Aut. rept. No. 18753
S/S "LEOPOLDVILLE"

ALTERATIONS ON AIR-OVERFLOW & SOUNDING PIPES

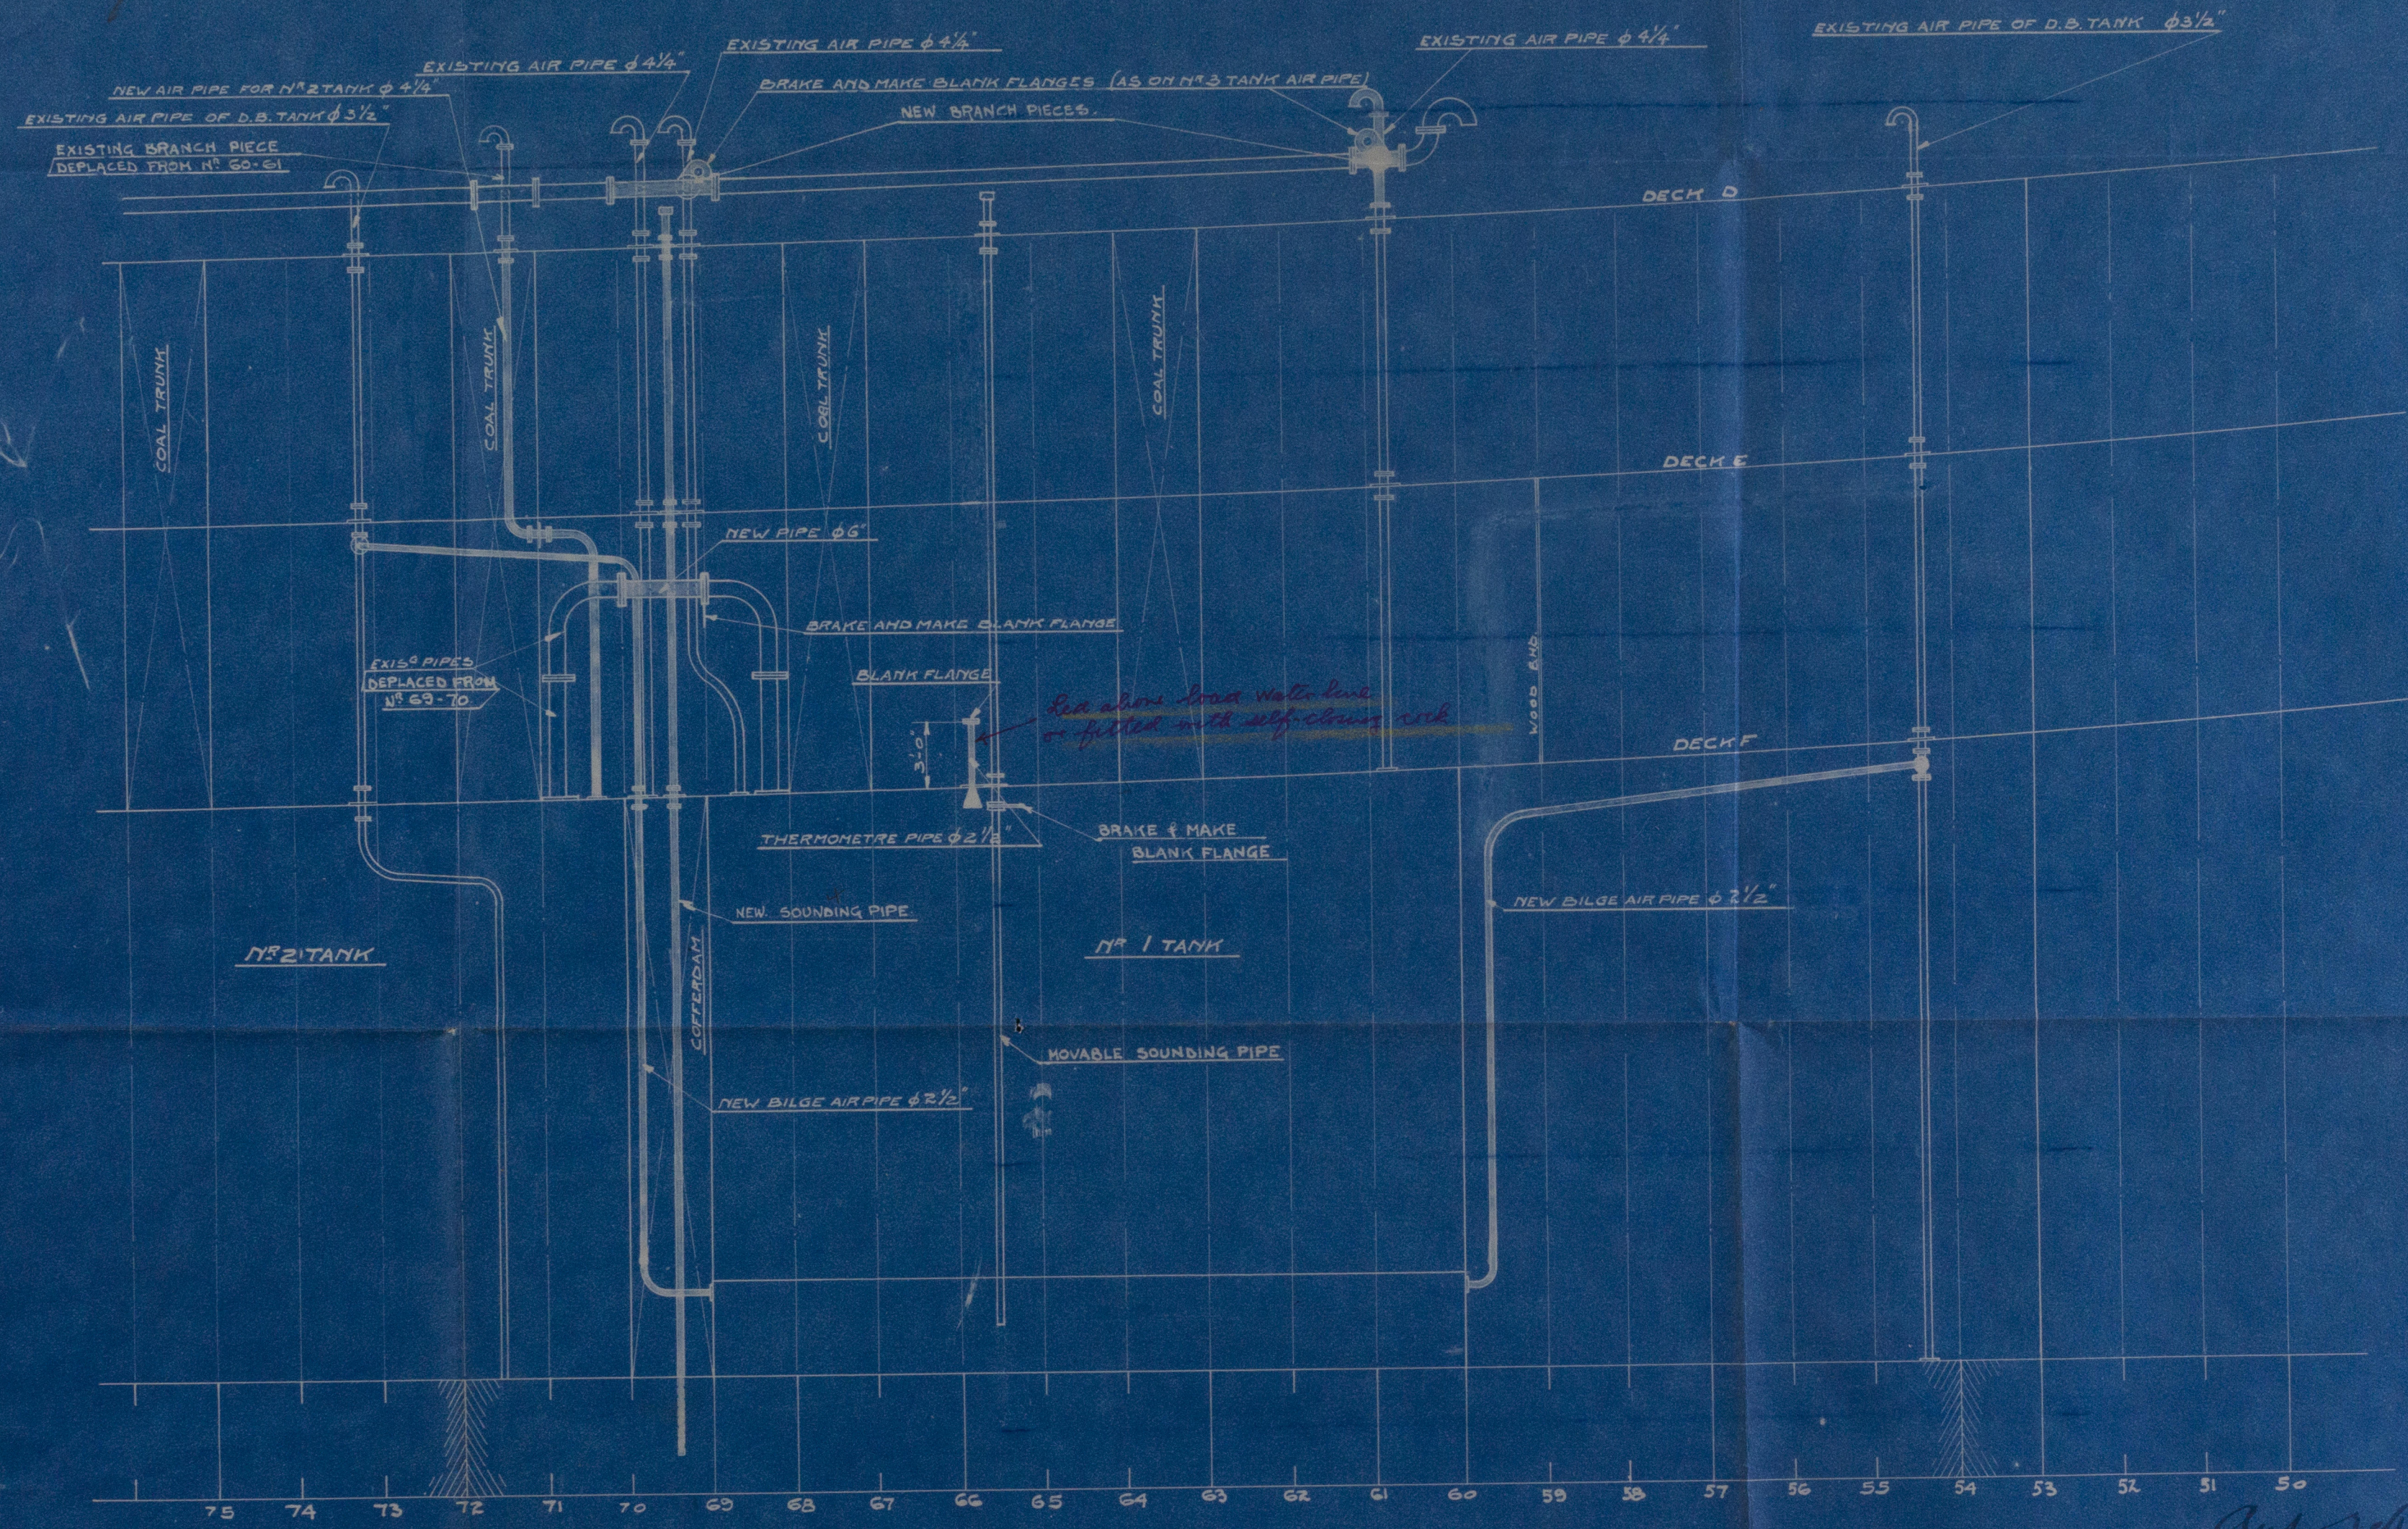
The flash point of the oil fuel to be above 150°F. and the remaining requirements of Section 20 of the Rules (432.3) to be complied with so far as they are applicable.

*Height of air pipes not altered
Scantlings of tanks
not affected.*
D.F.
11/3/33
